Improvements

1.Edges Design Modification:

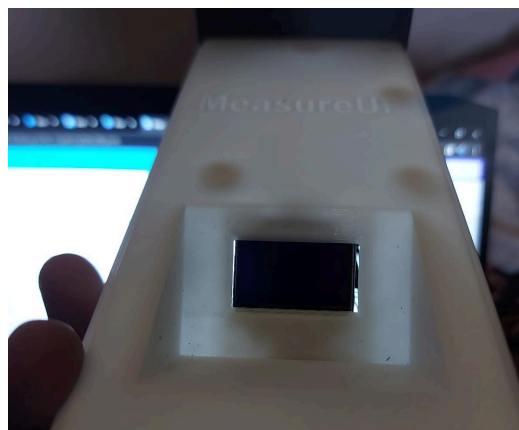
Make the edges curved like this and remove the slope on the other side.

4. Battery Hole:

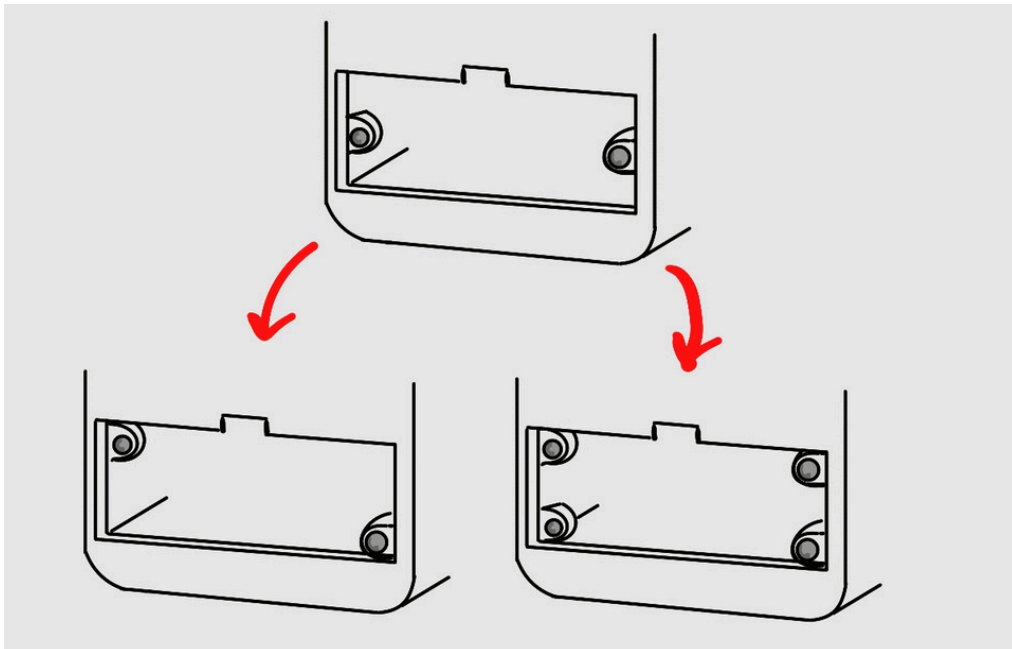
The magnets on both sides of the battery hole make it hard to put in the battery. Can you move one magnet up and the other down, so there's space in the middle for the battery?

5. Back Cover:

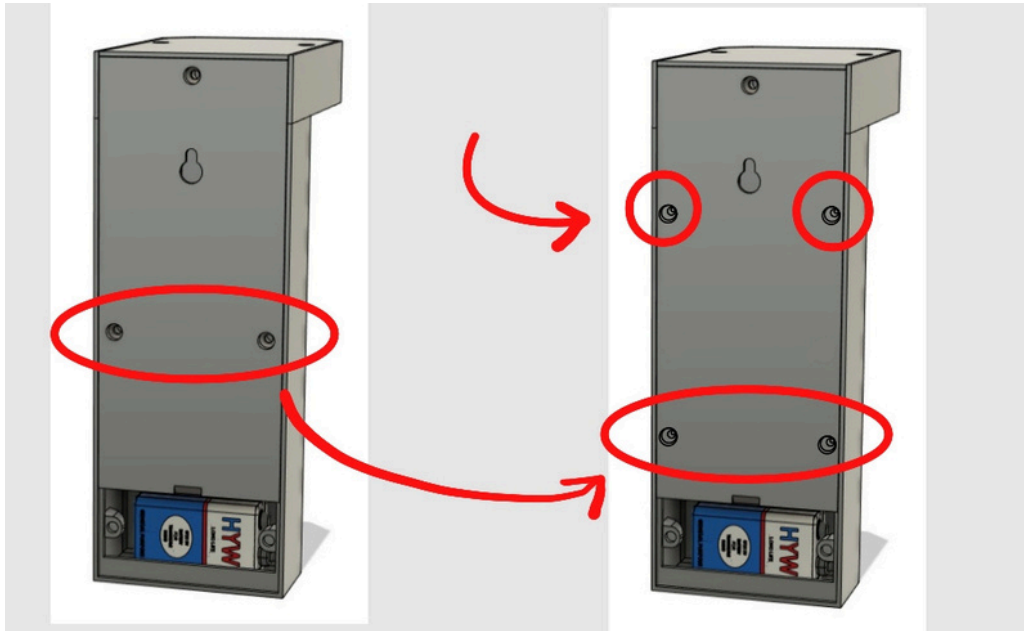
The back cover only has three screws, and it bends when you press it. Maybe add more screws or move them around?
